**UNITED STATES ENVIRONMENTAL PROTECTION AGENCY**  
**REGION 10**  
1200 Sixth Avenue  
Seattle, Washington 98101

**MEMORANDUM**

**SUBJECT:** J. H. Baxter, Arlington, WA Draft Remedial Action Pilot Study Work Plan & Draft Pilot Study Performance Monitoring Plan, both dated September 2007.

**Remedial Action Pilot Study Performance  
Monitoring Plan  
Stella-Jones (formerly J.H. Baxter & Co.) Wood Treating Facility  
Arlington, Washington**

Figure 3. Existing Monitoring Wells

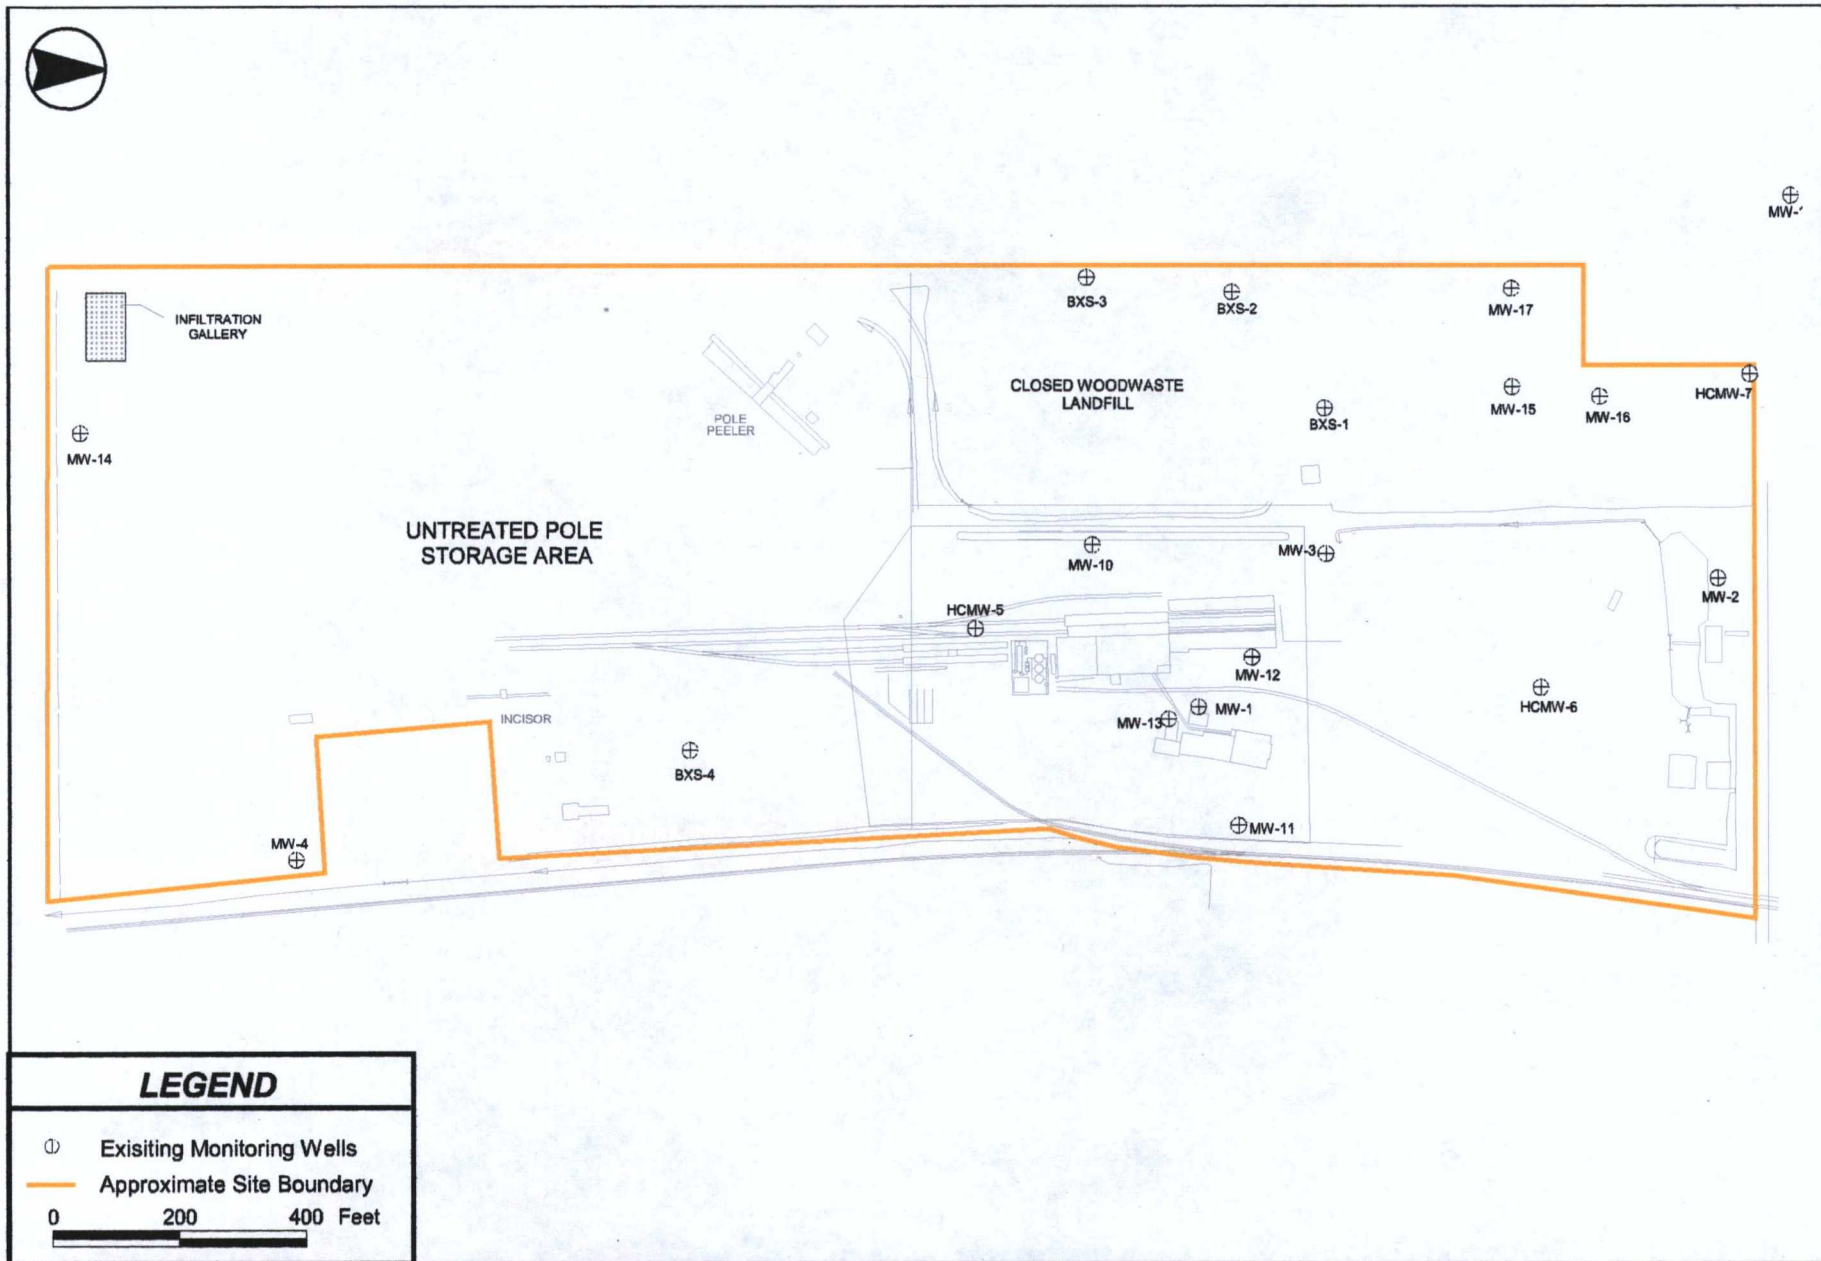
*Need SMW close to plume centerline 150 to 100 ft*

DRAFT	<b>MONITORING AND LNAPL RECOVERY WELLS NETWORK</b>		DATE: 08/13/2007
	J.H. BAXTER ARLINGTON, WASHINGTON		PROJECT NO.: 12706
	DRAWING M-1

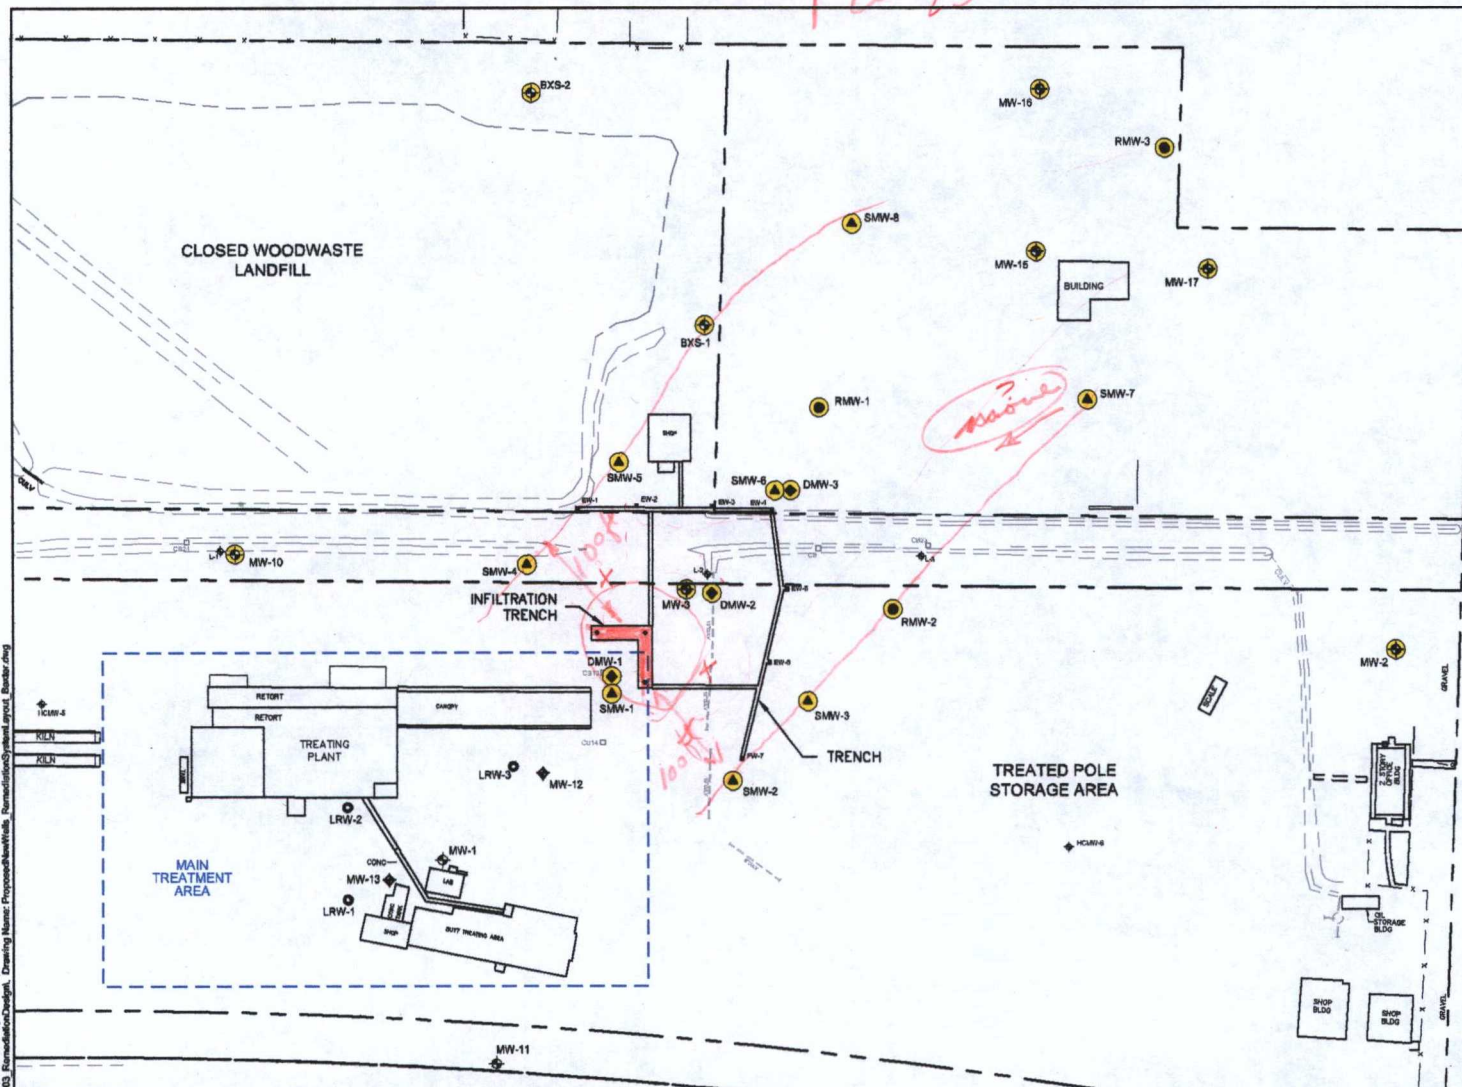
16. Drawing M-1 in Work Plan and Monitoring Plan. The facility consultants and EPA have now discussed, and agreed, in installing two additional shallow piezometers between the Infiltration Trench and wells SMW-3 and SMW-5. In addition, we agreed to move well

SMW-7 closer to RMW-2 in case the flows move towards the north past the extraction well system. The draft reports should be revised to show those changes.

*X add shallow piezometers*
